**PLANNED UNIT DEVELOPMENT
& SUBDIVISION STAFF REPORT****May 3, 2018**

<u>DEVELOPMENT NAME</u>	Inniss Subdivision
<u>SUBDIVISION NAME</u>	Inniss Subdivision
<u>LOCATION</u>	558 & 560 Houston Street (West side of Houston Street at the West terminus of Old Canal Street)
<u>CITY COUNCIL DISTRICT</u>	District 2
<u>AREA OF PROPERTY</u>	1 Lot / 0.3 ± acres
<u>CONTEMPLATED USE</u>	Planned Unit Development Approval to allow multiple buildings on a single building site, and to create one legal lot of record from multiple lots.
<u>TIME SCHEDULE FOR DEVELOPMENT</u>	Within one year of approval.
<u>ENGINEERING COMMENTS</u>

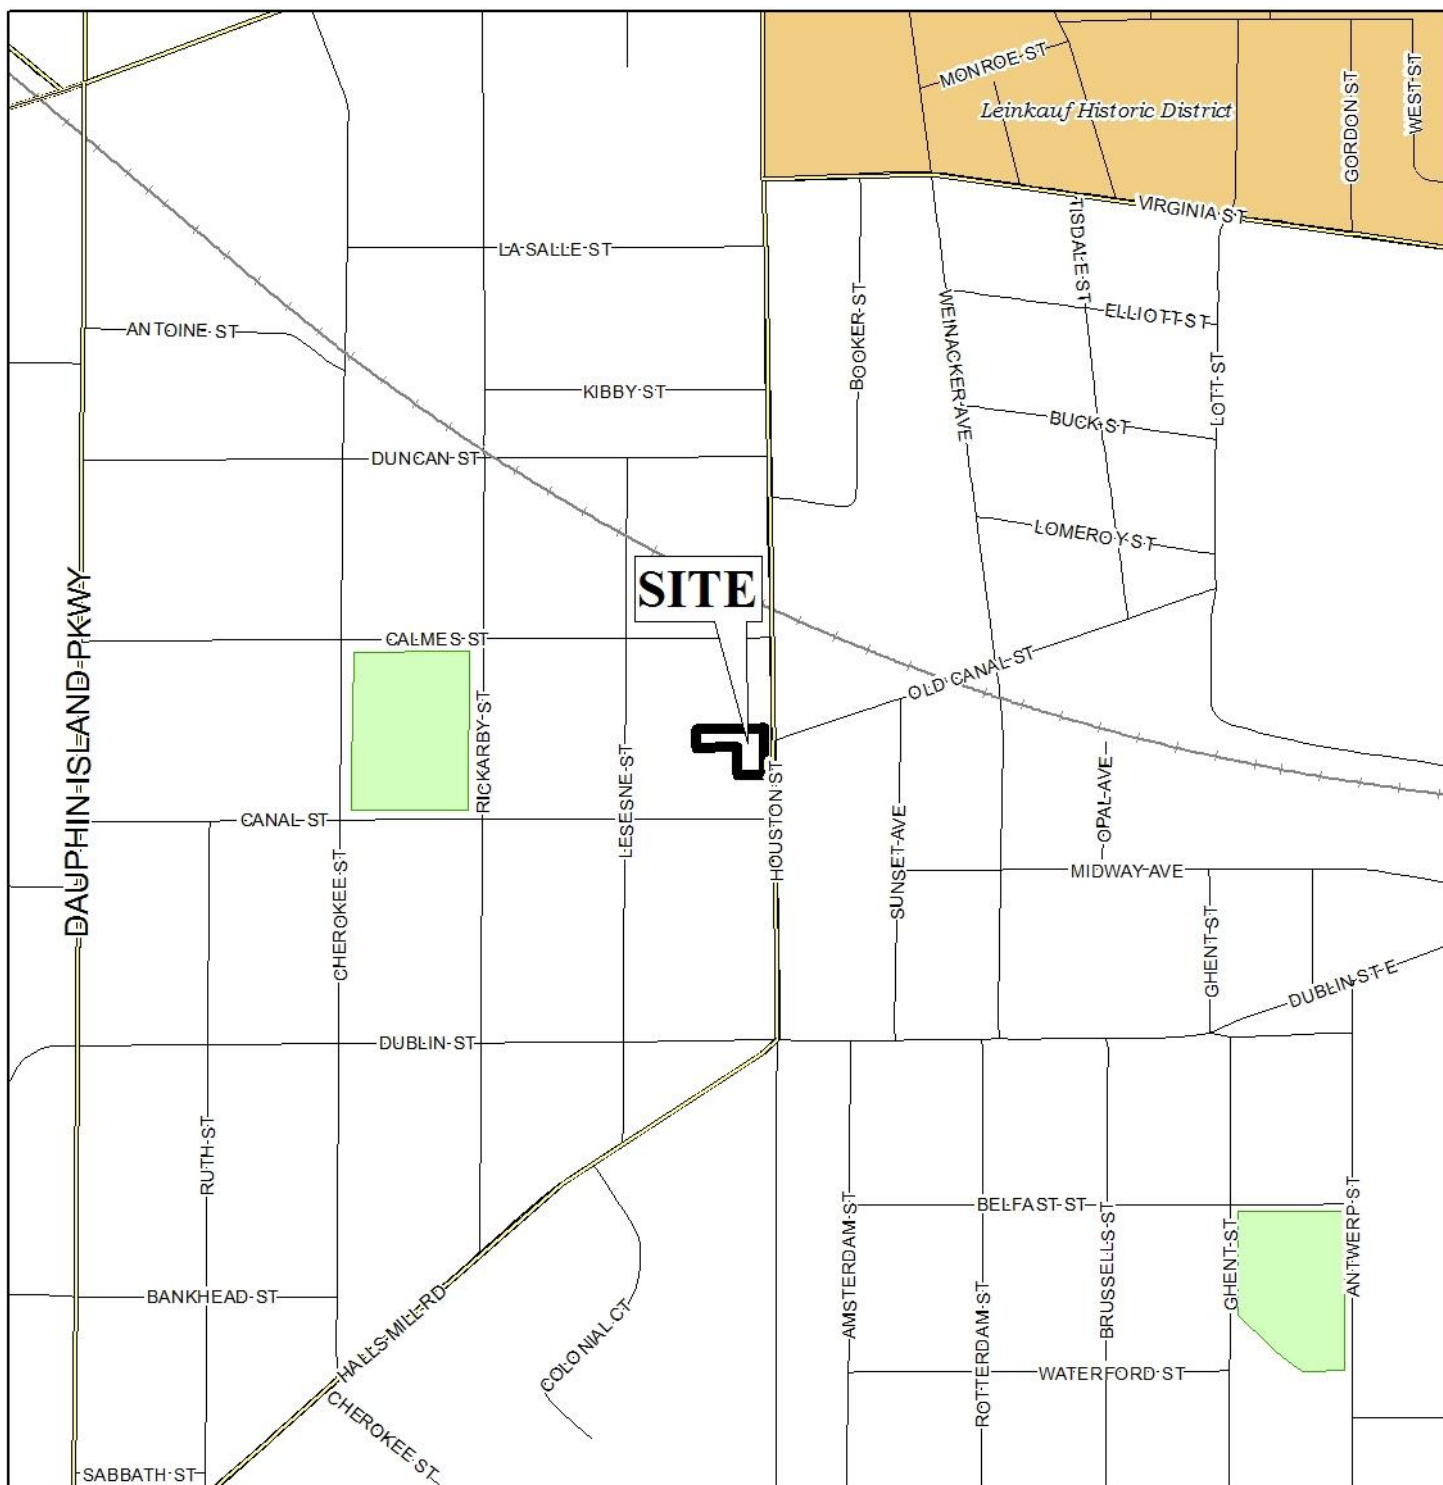
The 25' minimum building setback line is not depicted on the preliminary plat or on the site plan. Both the plat and the site plan should be revised to depict the 25' minimum building setback line.

- 1) retention the lot size in square feet and acres on the Final Plat;
- 2) revision of plat to depict the 25' minimum building setback line;
- 3) retention of the labeling of the right-of-way width along Houston Street;

- 4) placement of a note on the Final Plat stating that the lot is limited to the existing curb-cut, with any changes to the size, design and location to be approved by Traffic Engineering and comply with AASHTO standards;

SITE PLAN

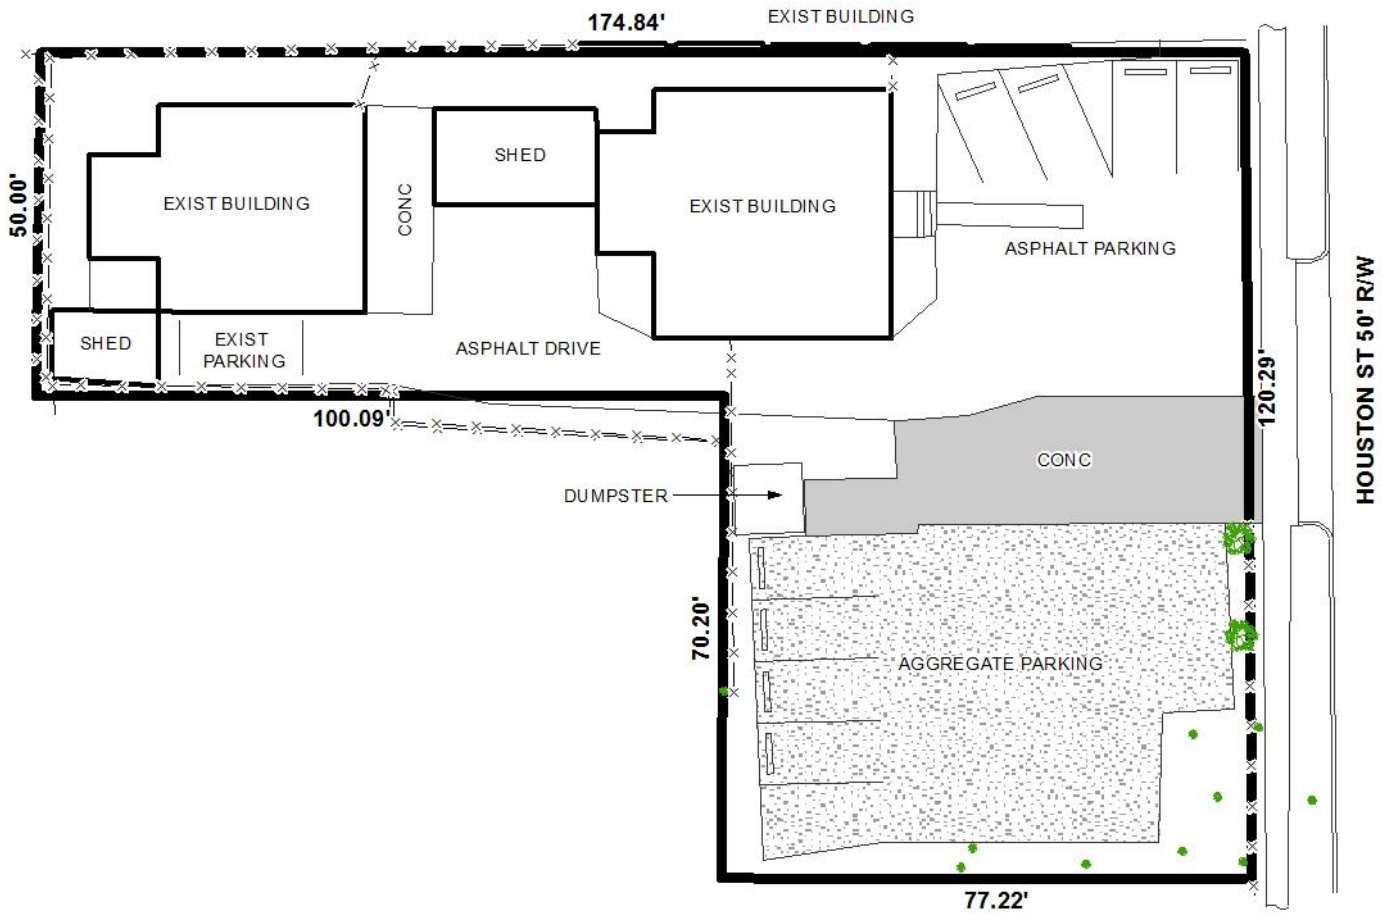
A dumpster is depicted on the site plan, less than 10 feet from abutting residential property. Section 64-4.D.9.a. of the Zoning Ordinance prohibits the placement of a dumpster within the residential protection buffer, which per Section 64-4.D.1. of the Zoning Ordinance must be at least 10 feet in width. Thus the proposed dumpster, pad and enclosure must be relocated to be outside of the protection buffer, and not within the 25-foot front setback or front yard.

It appears that after the expansion of the parking area, there will be a total of 9 parking spaces; however it appears that none of the spaces are identified as handicap accessible spaces. The applicant may wish to designate an accessible parking space. It should also be pointed out that the site plan depicts the expanded parking area as “aggregate parking,” however, parking lots must be surfaced with asphalt or concrete in B-2 districts, or a surfacing variance will be required.

The driveway leading to the mechanic shop, at the rear of the property, is only 8 feet 4 inches in width, from the side of the existing beauty salon building to the property line. However, the

submitted site plan indicates that the driveway encroaches onto the abutting residential property at least 2 feet 6 inches.

Finally, a privacy fence is depicted where the site abuts residentially zoned property, but should also be depicted where the site abuts residentially utilized property. The fence should be 6 feet in height, except within the front 25-foot setback, where it should only be 3-feet in height.

Planned Unit Development: Staff recommends that the applicant withdraw the PUD request and submit an application to the Board of Zoning Adjustment to address the building setback issues for the apparently unpermitted buildings, and to address the desire for aggregate surface parking.
